Access Compliance Report

Public Rights-of-Way

(Curb Ramps)

Intersection ID: 49559	Main Street: SPENCER_ST	Cross Street: NODA_BV	Location: NE
ADA ID: 270EE97E7C11	Ramp Type: BlendTrans2	Initial Pass/Fail: Fail	Overall Compliance: No
Codes/Mitigation Info/Possible Solution		Field Measurements/Component Compliance	
Severity Score: 1.25

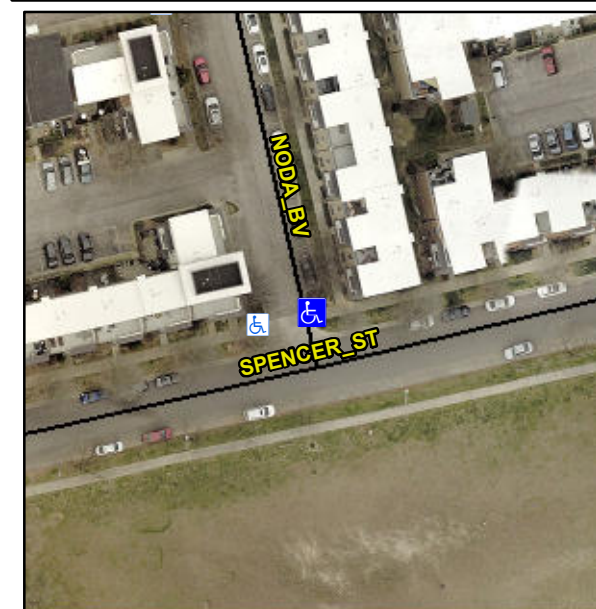
Compliance	Description	Data	Compliance	Description	Data
N/A	Ramp Length (in)	60.0	Yes	BlendTrans Slope (%)	2.2
Yes	Ramp Width (in)	70.5	No	BlendTrans XSlope (%)	2.7
N/A	Flare Type LT	N/A	N/A	Flare Type RT	N/A
N/A	Flare Slope LT (%)	N/A	N/A	Flare Slope RT (%)	N/A
N/A	Flare Traversable LT?	N/A	N/A	Flare Traversable RT?	N/A
N/A	Landing Length (in)	N/A	N/A	DWS Provided?	N/A
N/A	Landing Width (in)	N/A	N/A	DWS Contrast?	N/A
N/A	Landing Slope (%)	N/A	N/A	DWS Length (in)	N/A
N/A	Landing X Slope (%)	N/A	N/A	DWS Full Width?	N/A
N/A	Landing Curb? (Y/N)	N/A	N/A	DWS Offset (in)	N/A
N/A	Shared Landing?	N/A			
N/A	Gutter Ponding?	No	N/A	Gutter Slope (%)	2.5
N/A	Gutter Lip Ht (in)	0.0	N/A	Gutter X Slope (%)	2.4
N/A	Painted X Walk1?	Yes	N/A	Painted X Walk2?	N/A
	X Walk 1 Direction	To W		X Walk 2 Direction	N/A
	X Walk 1 Width (in)	63.0		X Walk 2 Width (in)	N/A
	X Walk 1 Slope (%)	1.8		X Walk 2 Slope (%)	N/A
	X Walk 1 X Slope (%)	1.6		X Walk 2 X Slope (%)	N/A

N/A	Ramp inside XWalk1?	Yes	N/A	Ramp inside XWalk2?	N/A
	Road Slope (%)	1.6		Clear Space?	N/A
	Road X Slope (%)	1.8	N/A	Clear Space to XWalk (in)	N/A
N/A	Any Obstructions?	No	N/A	Storm Grate/Utility Hazard?	No
	Obstruction Type			Storm Grate/Utility Type	
		N/A			N/A
			Yes	Surface Condition? (G/P)	Good
			N/A	Curb Slope (%)	2.5

Remove & Replace Curb Ramp With Two New Directional Ramps or Equivalent.
